# Comments on #PSP-25-0002 - Planning & Zoning: Preliminary Subdivision Plat

Application Number: #PSP-25-0002  
Application Type: Preliminary Subdivision Plat  
Date: February 4, 2026  
Address: 6521 Mitchell Mill Road

**ROLESVILLE ESTATES**  
PRELIMINARY SUBDIVISION PLAN  
PSP-25-04 (PSP-25-0002)  
TOWN OF ROLESVILLE | WAKE COUNTY | NORTH CAROLINA

SHEET  
C200

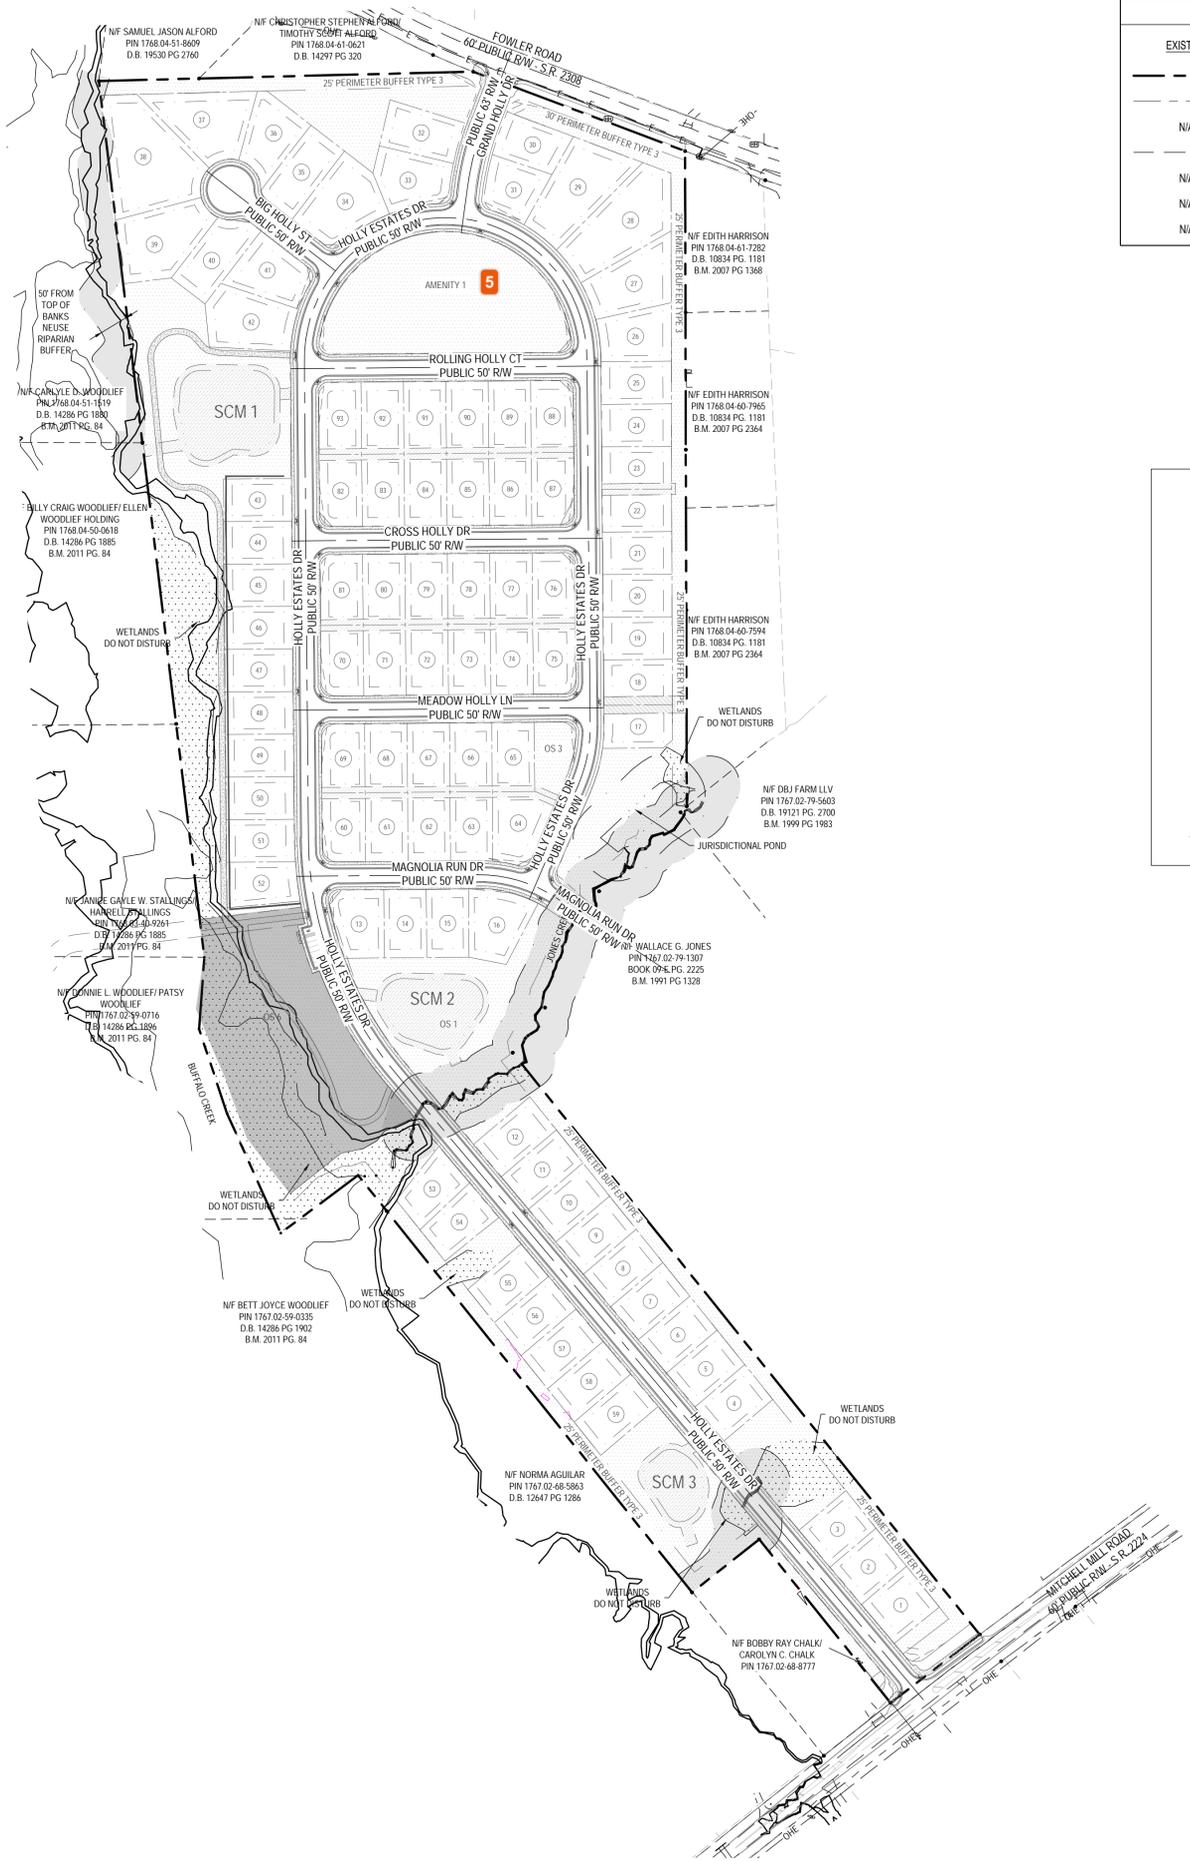
NCDOT - Joshua Zhang is no longer there, replacement is [tddeaveiro@ncdot.gov](mailto:tddeaveiro@ncdot.gov) Thomas Deaveiro. The note seems sufficient for Lot 30 Driveway but the DOT must approve. I will select Requires Resubmit for DOT so that Thomas can review this on V3.

16. CONTRACTOR TO ENSURE DRIVEWAY ON LOT 30 LOCATED AS FAR SOUTH AS POSSIBLE TO MAXIMIZE THE DISTANCE BETWEEN STREET A AND FOWLER ROAD ENTRANCE.

SHEET  
C400

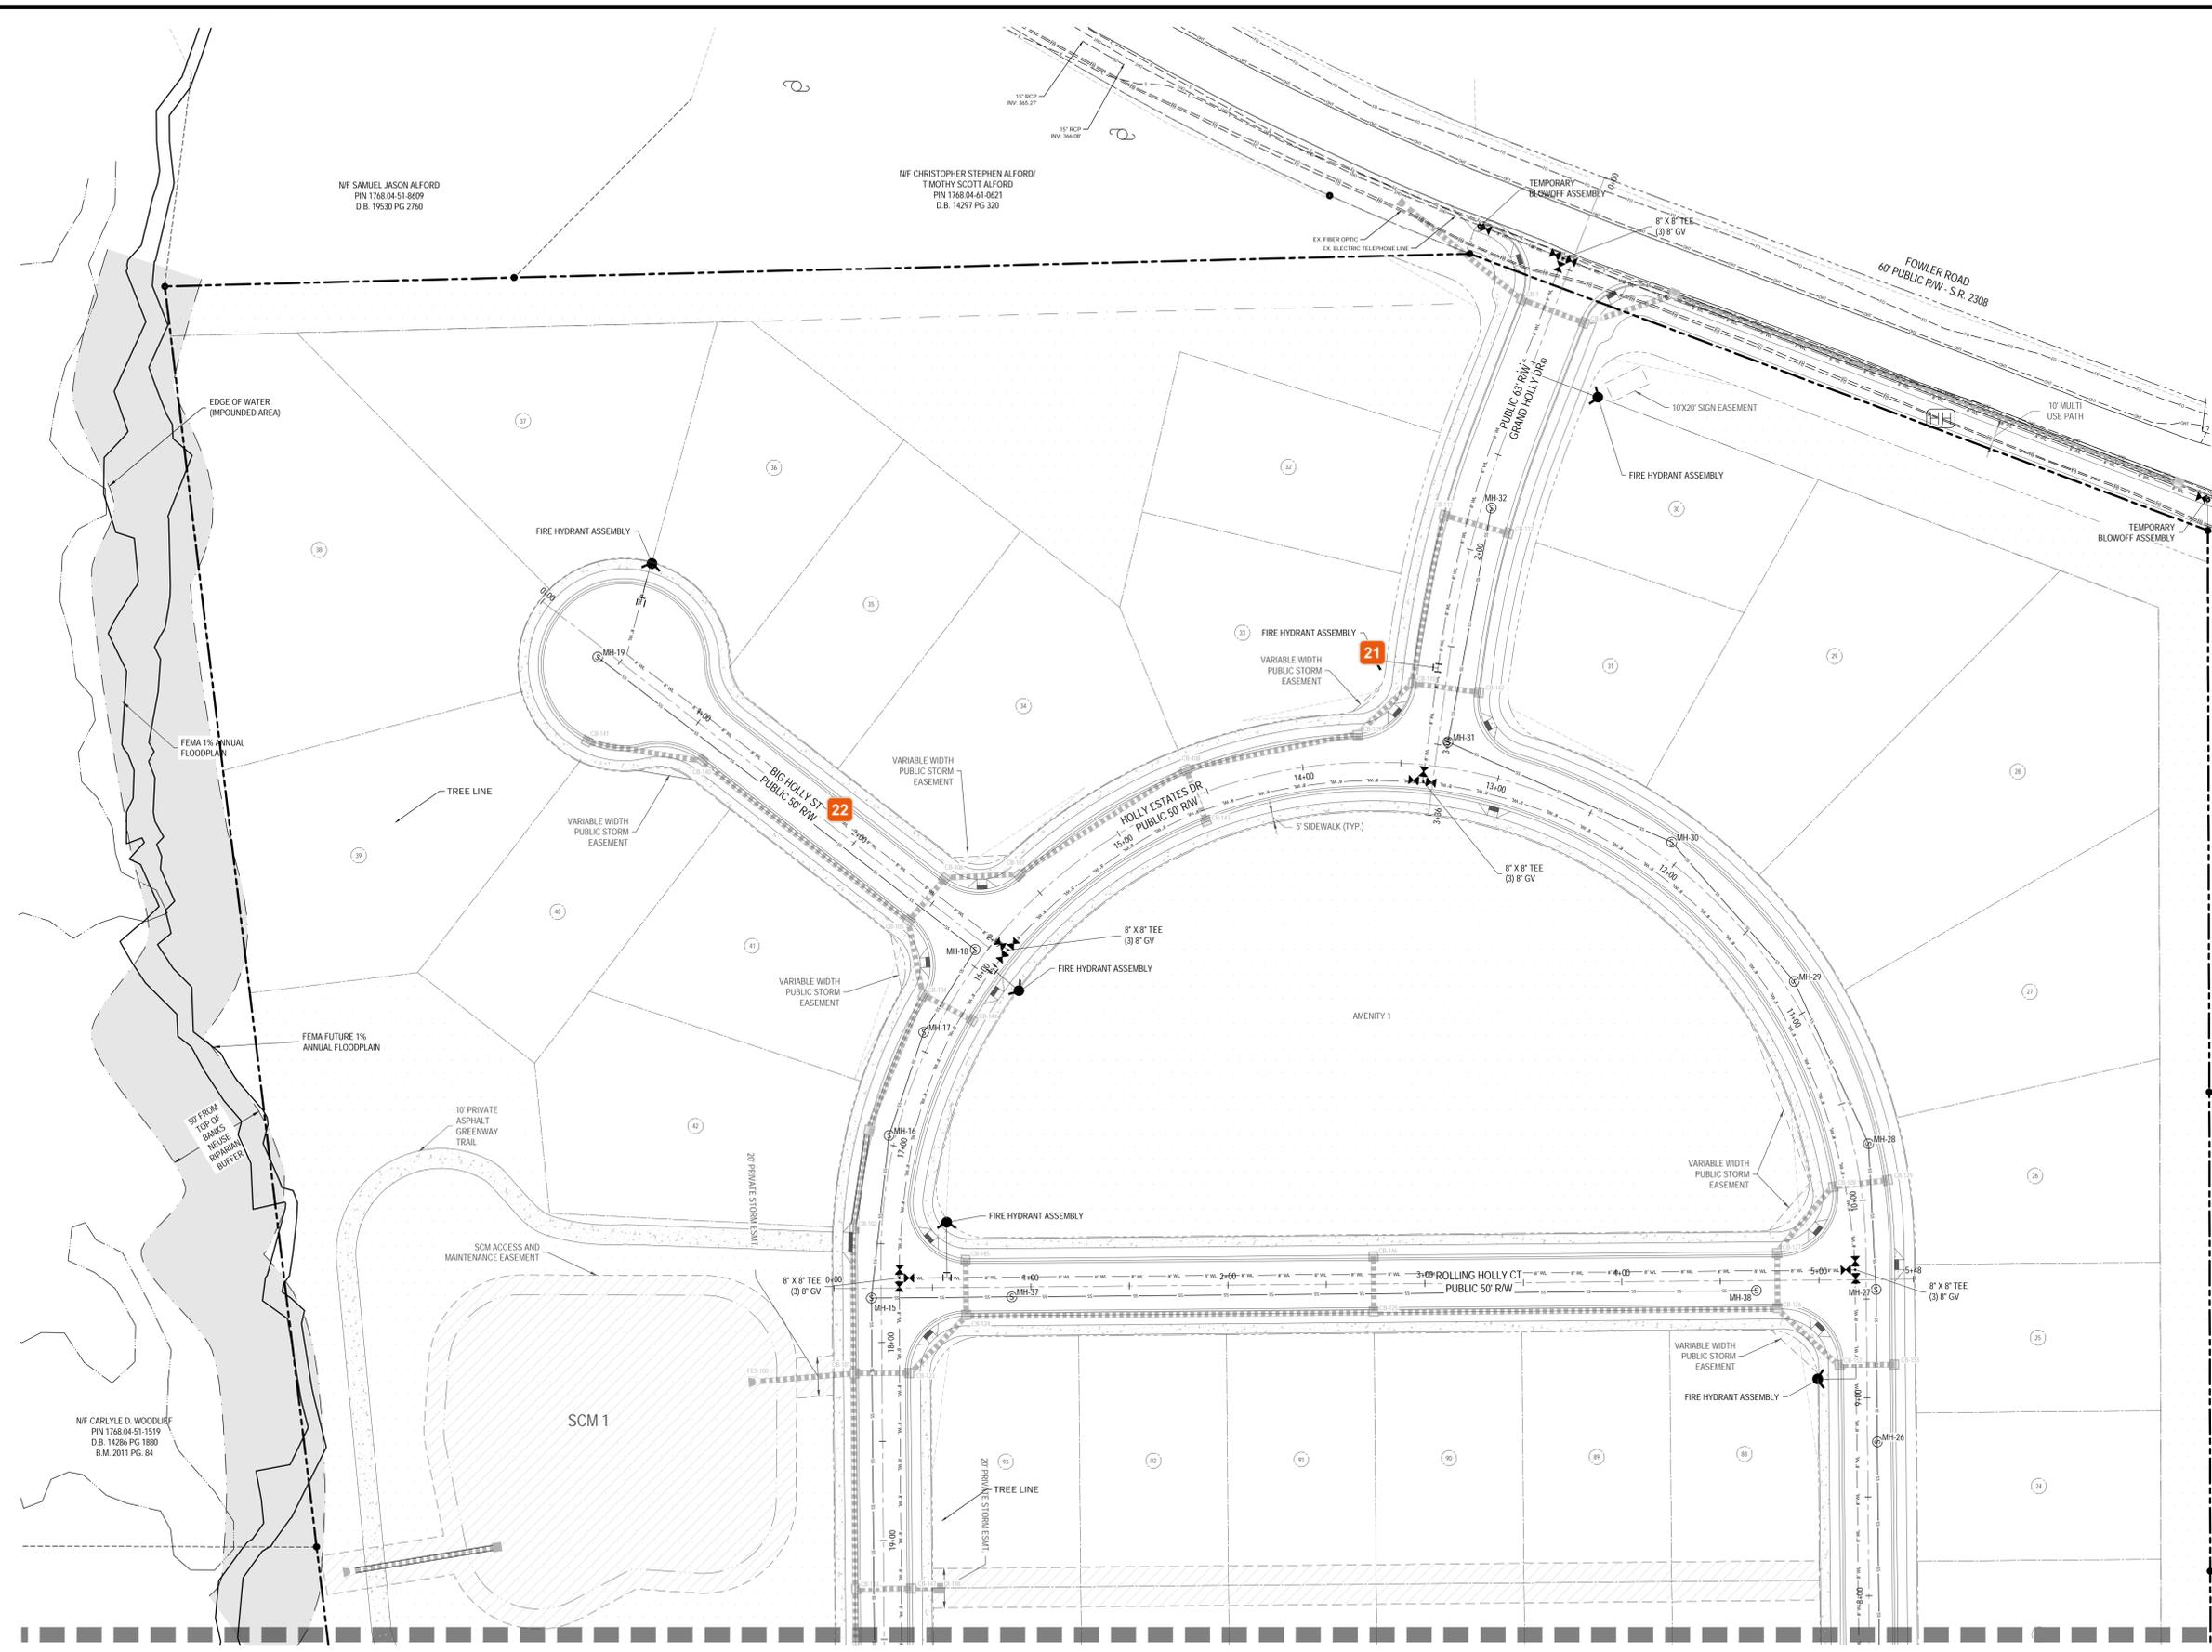
Show a 3' COR water and SS strip easement along property frontage of every lot. There are areas where there is no ROW behind sidewalk for hydrant, meters, or SSCO.

The two hydrants at Fowler entrance can be moved into the ROW or placed in the strip easement mentioned in my previous comment. The strip easement should resolve the issue with all proposed hydrants.
